# Work Order ID 107545

Item Name: Crosstube Turning Detail

<b>DART AEROSPACE LTD</b>	<b>Work Order:</b>	107545
<b>Description: Crosstube Assembly (206L High Fwd)</b>	<b>Part Number:</b>	D206-667-143
<b>Inspection Dwg: D206-667-143 Rev: C</b>		<b>Page 1 of 2</b>

DRAWING NO. D206-667-143	TITLE CROSSTUBE ASS'Y (206L HIGH FWD)	REV. C	DART AEROSPACE LTD ENGINEERING ORDER		D.E.O. NO. D206-667-143-C-1	SHEET NO. SHEET 1 OF 1	SCALE NTS
DRAWN <i>q</i>	CHECKED <i>ASS</i>	MFG. APPR. <i>JB</i>	APPROVED <i>WD</i>		DE APPR. <i>WD</i>		
DATE 11.07.15	DATE 11.07.20	DATE 11.07.21	DATE 11.07.21		DATE 11.07.21

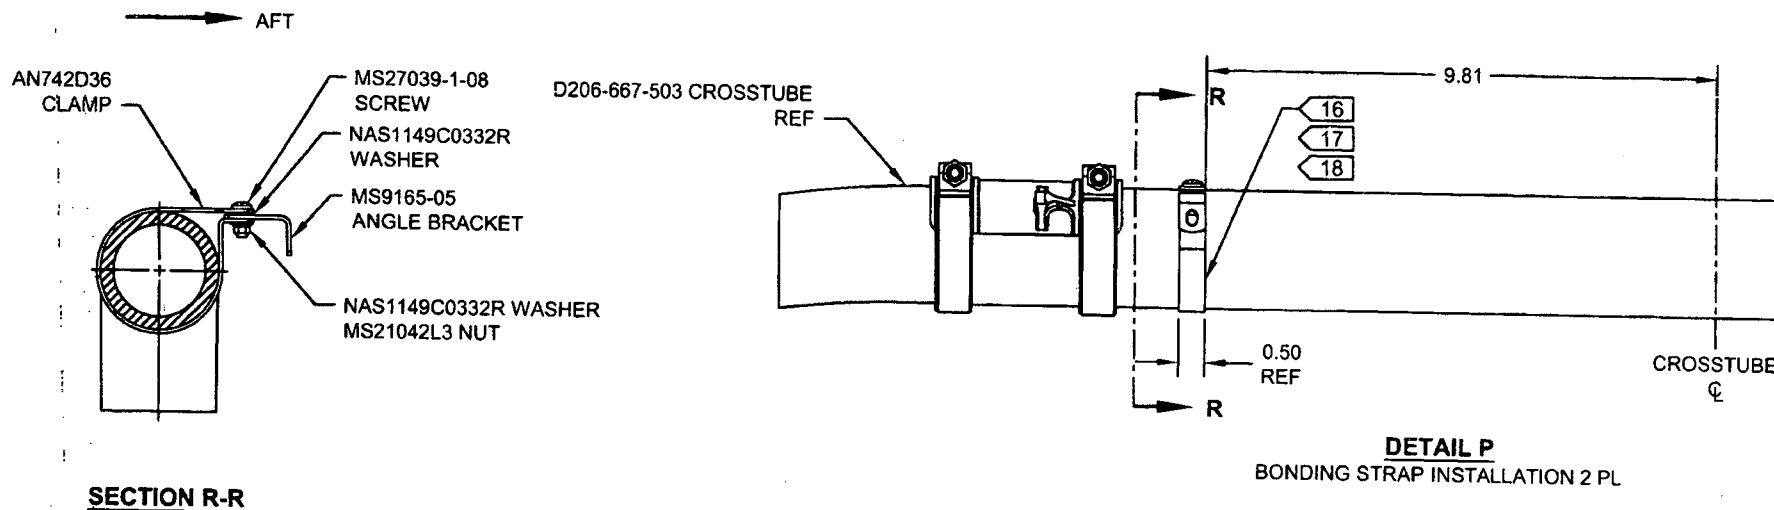
ADD ELECTRICAL GROUNDING STRAP

ITEM	QTY -143	PART NUMBER	DESCRIPTION
1	X	D206-667-143	CROSSTUBE ASSEMBLY (206L HIGH FWD)
⚡			
10	2	AN742D36	CLAMP
11	2	MS9165-05	ANGLE BRACKET
12	2	MS21042L3	NUT (OR MS21042-3)
13	2	MS27039-1-08	SCREW
14	4	NAS1149C0332R	WASHER (OR AN960C10L)

- 16) MASK AREA UNDER CLAMP PRIOR TO PAINTING
- 17) SEAL EDGES WHERE AN742D36 CLAMP MEETS WITH THE CROSSTUBE USING SIKAFLEX-241/291 OR MIL-S-8802 CLASS B2 OR PROSEAL 890 SEALANT
- 18) PERFORM RESISTANCE CHECK TO ENSURE MAX RESISTANCE IS 10 MILLIOHMS
